Access Compliance Report

Public Rights-of-Way

(Curb Ramps)

Intersection ID: 48431	Main Street: SEAMILL_RD	Cross Street: KINNAIRDS_ST	Location: NE
ADA ID: 5DCD1A3DD05E	Ramp Type: PerpDiag	Initial Pass/Fail: Fail	Overall Compliance: No
Severity Score: 21.25			
Codes/Mitigation Info/Possible Solution		Field Measurements/Component Compliance

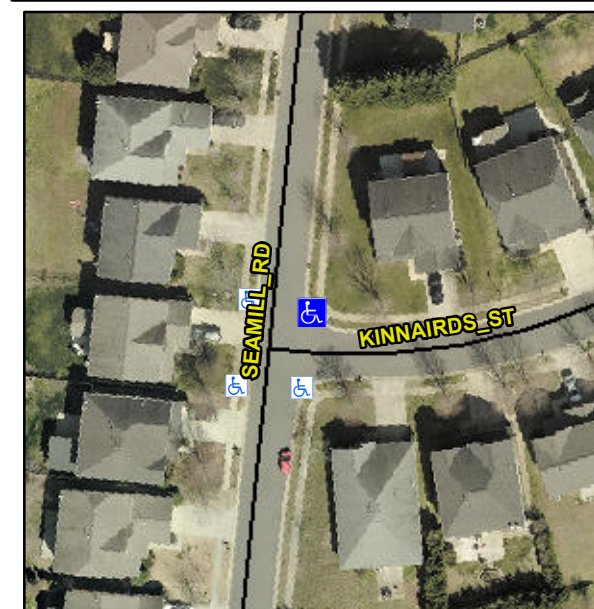
Not Found, R304.5.1, R304.2.2

Compliance	Description	Data	Compliance	Description	Data
N/A	Ramp Length (in)	47.0	No	Ramp Slope (%)	8.5
No	Ramp Width (in)	47.5	Yes	Ramp XSlope (%)	0.4
N/A	Flare Type LT	N/A	N/A	Flare Type RT	N/A
N/A	Flare Slope LT (%)	N/A	N/A	Flare Slope RT (%)	N/A
N/A	Flare Traversable LT?	N/A	N/A	Flare Traversable RT?	N/A
N/A	Landing Length (in)	N/A	N/A	DWS Provided?	N/A
N/A	Landing Width (in)	N/A	N/A	DWS Contrast?	N/A
N/A	Landing Slope (%)	N/A	N/A	DWS Length (in)	N/A
N/A	Landing X Slope (%)	N/A	N/A	DWS Full Width?	N/A
N/A	Landing Curb? (Y/N)	N/A	N/A	DWS Offset (in)	N/A
N/A	Shared Landing?	N/A			
N/A	Gutter Ponding?	N/A	N/A	Gutter Slope (%)	N/A
N/A	Gutter Lip Ht (in)	N/A	N/A	Gutter X Slope (%)	N/A
N/A	Painted X Walk1?	No	N/A	Painted X Walk2?	No
	X Walk 1 Direction	To NW		X Walk 2 Direction	To SW
N/A	X Walk 1 Width (in)	N/A	N/A	X Walk 2 Width (in)	N/A
	X Walk 1 Slope (%)	1.1		X Walk 2 Slope (%)	2.0
	X Walk 1 X Slope (%)	2.4		X Walk 2 X Slope (%)	2.9

Remove & Replace Curb Ramp With Two New Directional Ramps or Equivalent.
